**CLIENT NAME** Fort Wayne Community Schools  
**Project Name & Number:** Wayne HS Dining - 20230232  
**Date:** 10/24/2024

## **ADDENDUM NO. 2**

**1 POWER PLAN - MAIN LEVEL - UNIT F**  
SCALE: 1/8" = 1'-0"  
NORTH

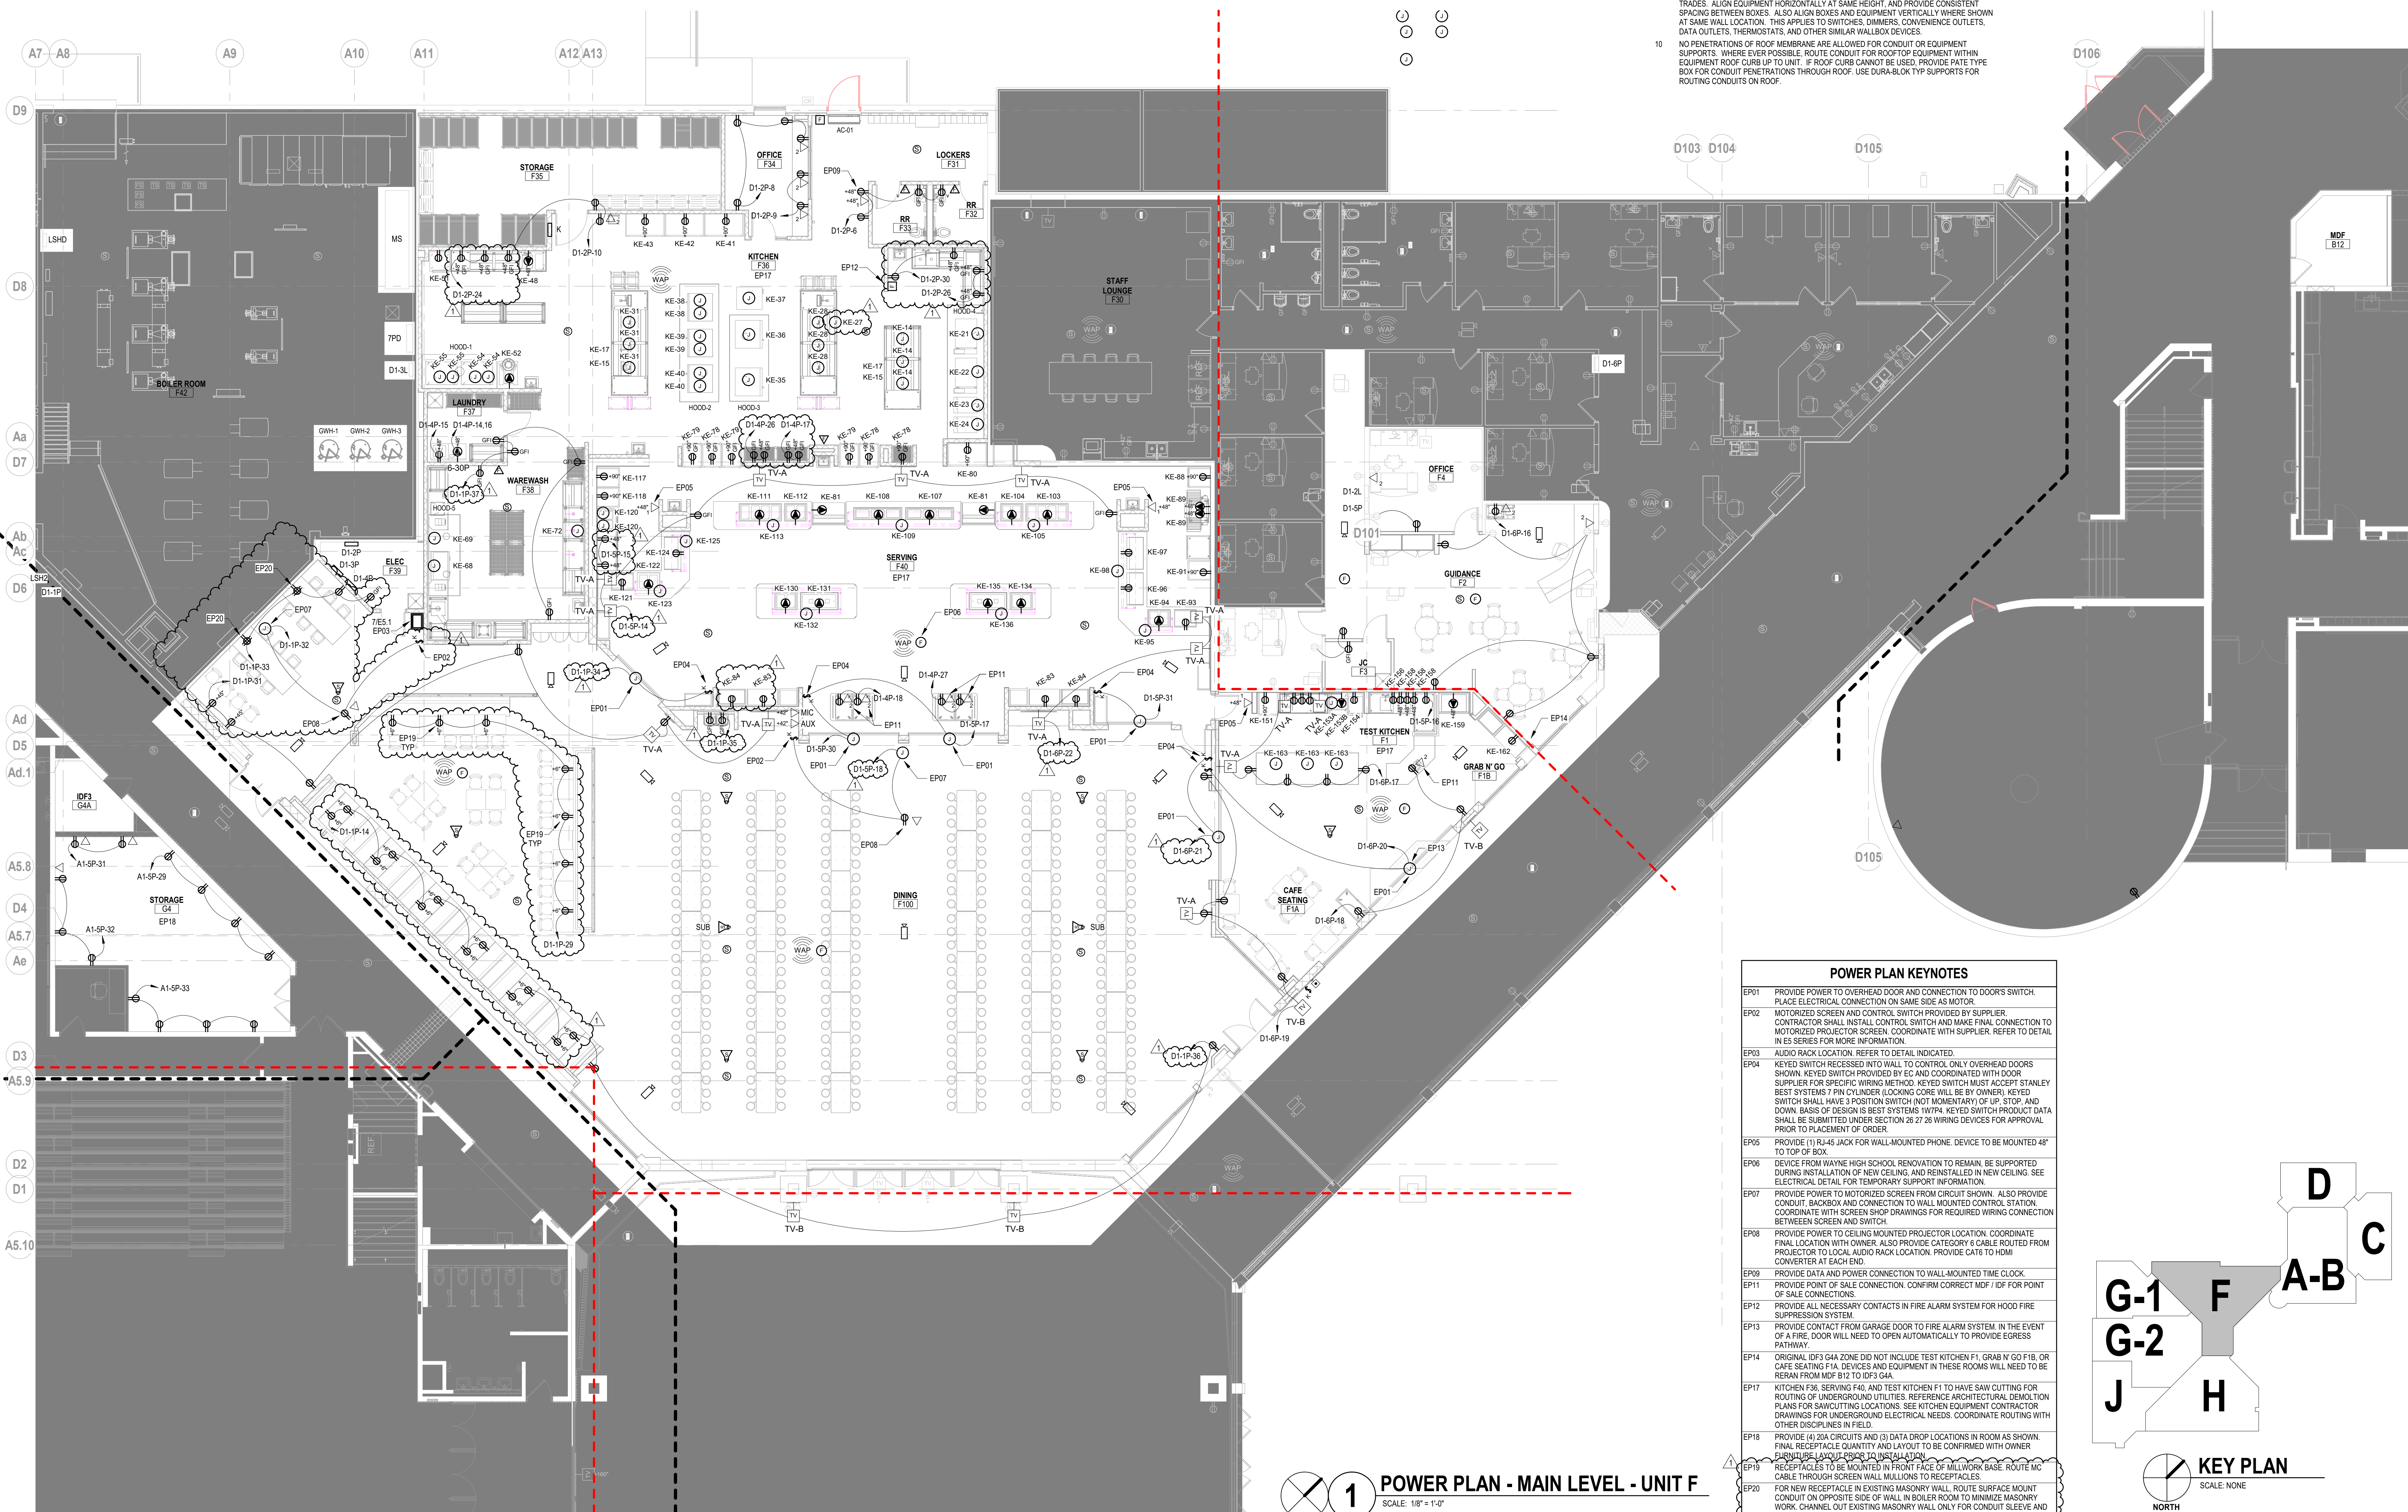
Location: Drawings, Sheet E2.1F - Power Plan - Main Level - Unit F, E6.2 - Panel Schedules  
Description: Additional receptacles added to booths, banquets, and walls near seating in Dining F100. See keynotes for specific power routing methods.

Location: Drawings, Sheet E2.1F - Power Plan - Main Level - Unit F, E6.2 - Panel Schedules, E6.3 - Electrical Schedules  
Description: Receptacles, direct connections, and circuitry coordinated to align with final kitchen equipment drawings.
